**A57 Link Roads**

**TR010034**

**9.88 Applicant's comments on Deadline 11  
submissions**

### A57 Link Roads Development Consent Order 202[x ]

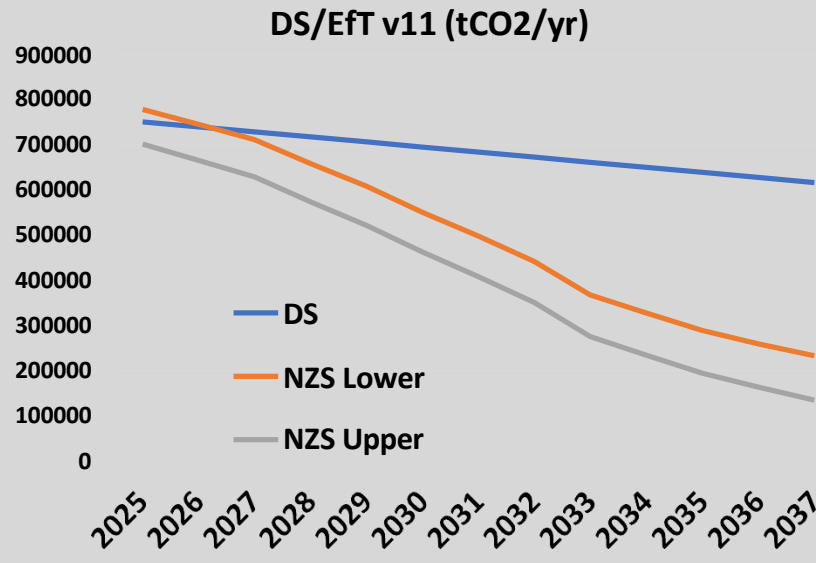
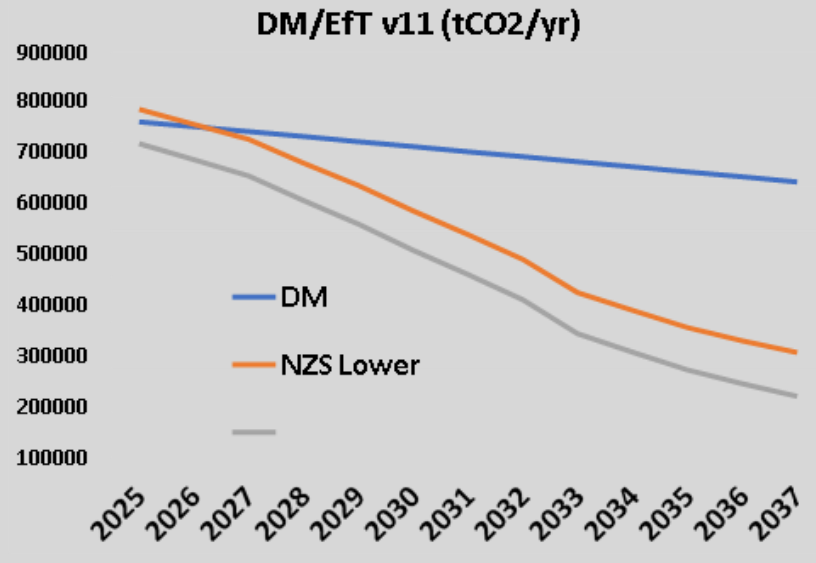
Reference	IP Issue	NH Response
	<p>34 This is based as before on the assumption that the traffic model study area represents a proxy for a notional local and regional area<sup>1</sup>. For an indicative sense of this approach, the graphs below are presented with assumptions in the footnotes</p> <div><p><b>DS/EfT v11 (tCO<sub>2</sub>/yr)</b></p><p><b>DM/EfT v11 (tCO<sub>2</sub>/yr)</b></p></div> <p>35 The first observation is that neither of these views of the EfT v11 traffic model (ie DS or DM) remotely aligns with the NZS delivery pathway for the transport sector. The applicant's</p> <p>This essentially provides scaled projections for the data (DS or DM) and the NZS calculated on the basis of the study area as a local/regional area, normalised to 2025.</p> <p>response to this has been to multiply the data by an idealised factor, each year, to make the curve fit (see my response above on the so called TDP Sensitivity test, and the applicant's response at REP9-027/8.14.3/4). As above, this is just the numerical application of proposition 3 [A57/REP10-011/9]: the "overarching assertion of TDP success" to the data: it aligns more with</p>	<p>The assumptions in EFT v11:</p> <ul style="list-style-type: none"><li>• Predate the announcement by the Government in July 2021 to end the sale of new petrol and diesel vehicles by 2030, and that all new cars and vans will be required to be fully zero emission at the tailpipe by 2035. Assumptions within EFT v11 are for a phase out of sales of new petrol and diesel vehicles by the target date of 2040.</li><li>• Predate the announcement by the Government in November 2021 to phase out new, non-zero emission heavy goods vehicles weighing 26 tonnes and under by 2035, with all new HGVs sold in the UK to be zero emission by 2040. Assumptions within EFT v11 do not include any electrification of heavy goods vehicles.</li></ul>

Reference	IP Issue	NH Response
	<p>a mystical belief than with any evidence that it can be delivered.</p> <p>The first DS/EfT v11 graph above (blue curve = DS) indicates that transport carbon emissions in the study area will not reduce to 2037 in line with the NZS. In fact, they are very misaligned with the NZS. Where TDP policies are successful, the blue line will move towards the orange and grey upper/lower NZS lines, but as there is no carbon quantification of TDP policies, nor data supporting that they are designed to secure their emission reduction objectives, it is impossible to make any claim about how much the blue will move towards the orange and grey lines.</p> <p>36 The second observation is that this is true also for the DM/EfT v11 graph above (blue curve = DM). This indicates that transport carbon emissions in the study area will not reduce to 2037 in line with the NZS without the scheme either.</p> <p>37 Together these observations, indicate that only a sustainable package implemented without the current scheme in place ('do-something-else'), that is designed to secure the required policy objectives, would have the potential to provide the required policy delivery mechanisms as I, and other IPs, suggest in the joint letter at A57/REP10-017.</p>
